ENGINE - POWER PLANT - REVISED CLIPPING TO PROVIDE INCREASED CLEARANCE BETWEEN OIL  
QUANTITY TRANSMITTER AND EEC HARNESS - CATEGORY CODE 6 - MOD.ENG-71-0118

V2500-ENG-71-0118

**SERVICE BULLETIN**

. Location of clip point 1106 and new clip point 1189  
Fig 1

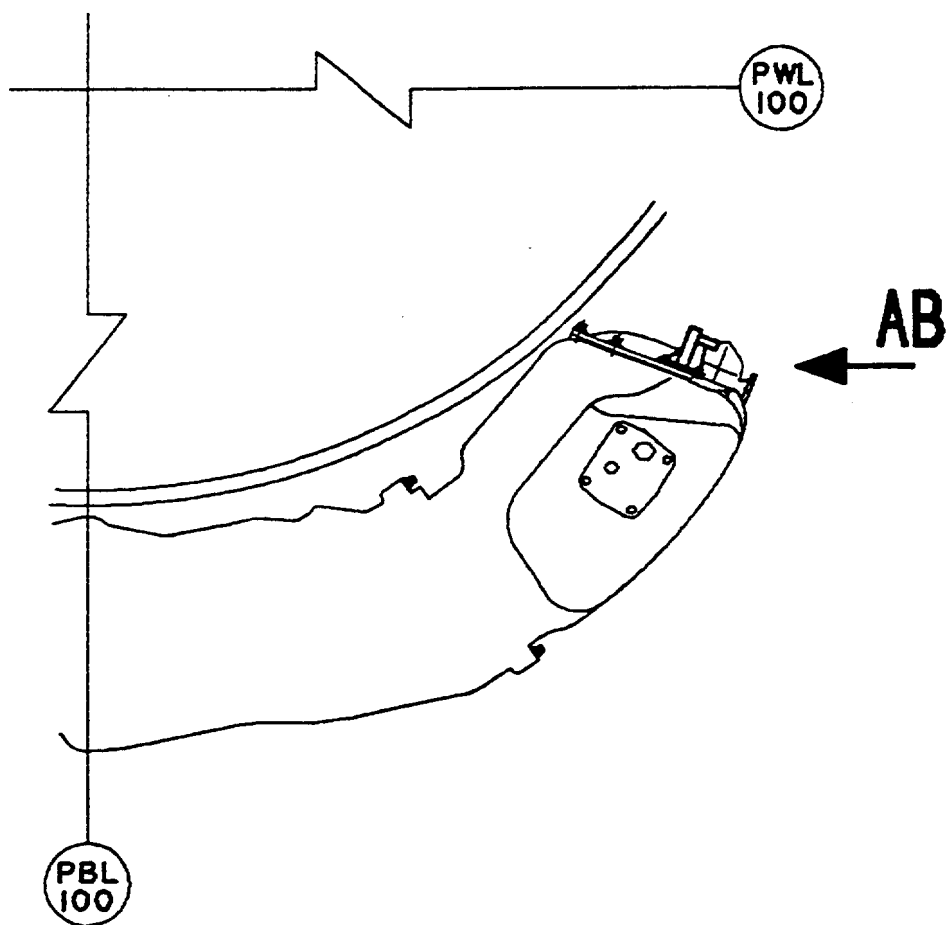
The EEC, general services and ignition supply harness bundle which was clipped from an oil tube lug at Clip Point 1106 is now clipped to a new bracket at Clip Point 1189. The bracket is secured by 2 of the oil quantity transmitter attaching bolts.

- (1) Remove the bolt, washer, clip and nut from clipping point 1106. Refer to Figures 1, 3 and 4.
- (2) Remove the two oil quantity transmitter securing bolts adjacent to the EEC, general services and ignition supply harness bundle.
- (3) Install the new 6A5746 bracket onto the oil quantity transmitter using the two bolts removed at step (2). Refer to figures 5 and 6.
- (4) Torque the bolts to 100 lbfin (11,3 Nm).
- (5) Attach the EEC, general services and ignition supply harness bundle to the 6A5476 bracket at clipping point 1189 using the 4W0103 bolt, AS62517 clip and 4W0043 clip nut. Refer to Figures 5 and 7.
- (6) Torque the bolt at clipping point 1189 to 36 to 45 lbfin (4 to 5 Nm).

View on arrow AB showing harness location - Before alteration  
Fig.3

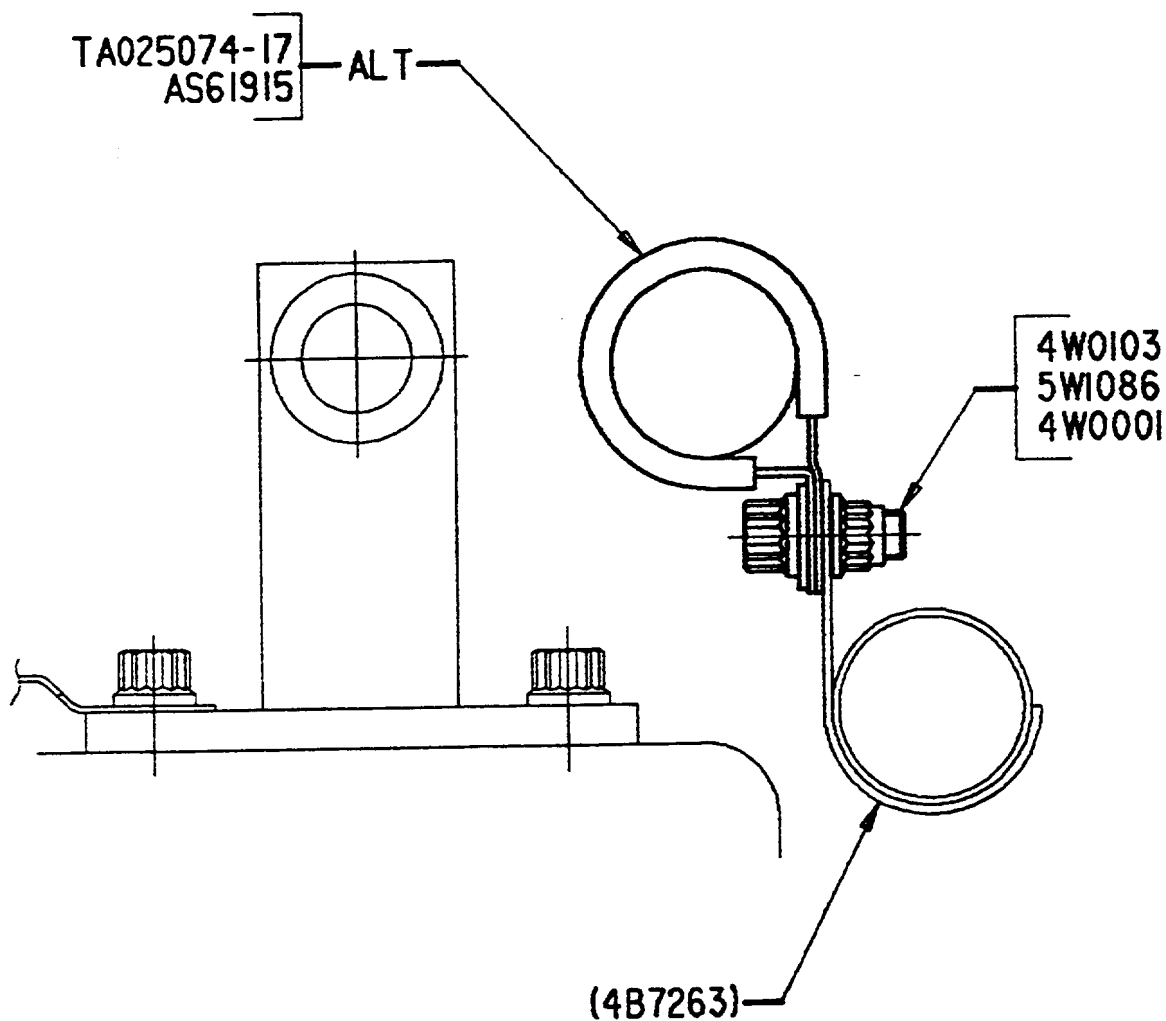
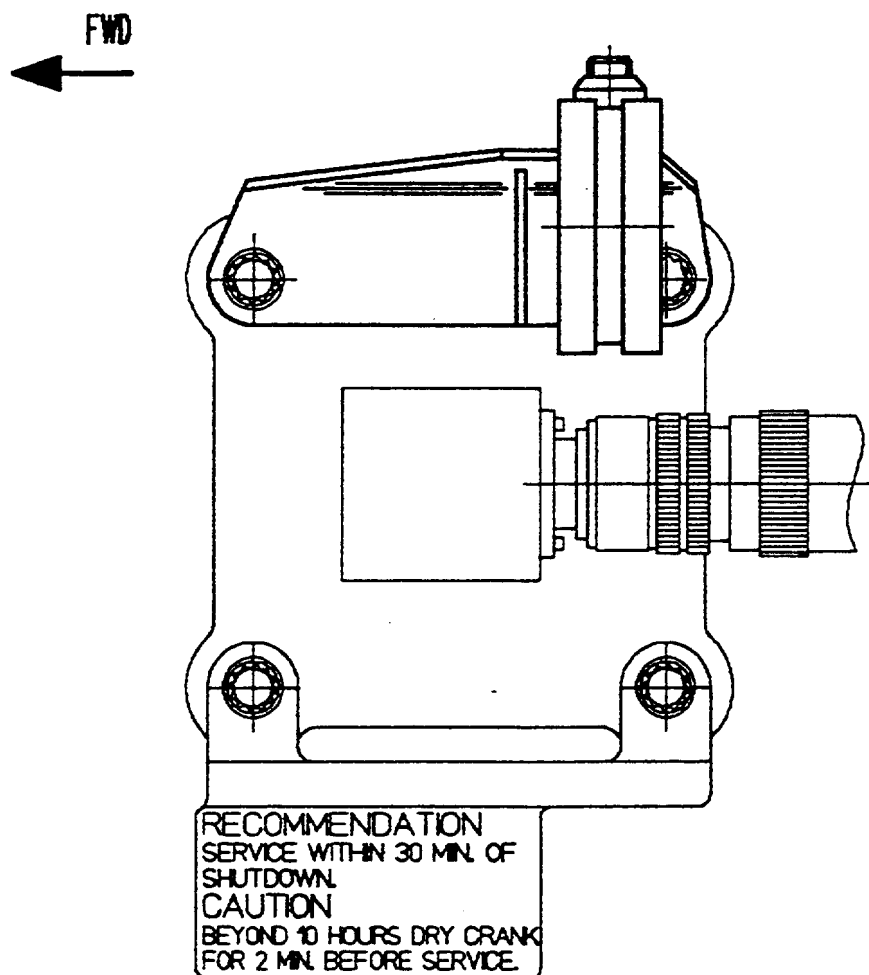
It has been reported that there is insufficient clearance between the oil quantity transmitter electrical connector backshell and the adjacent harness looms.
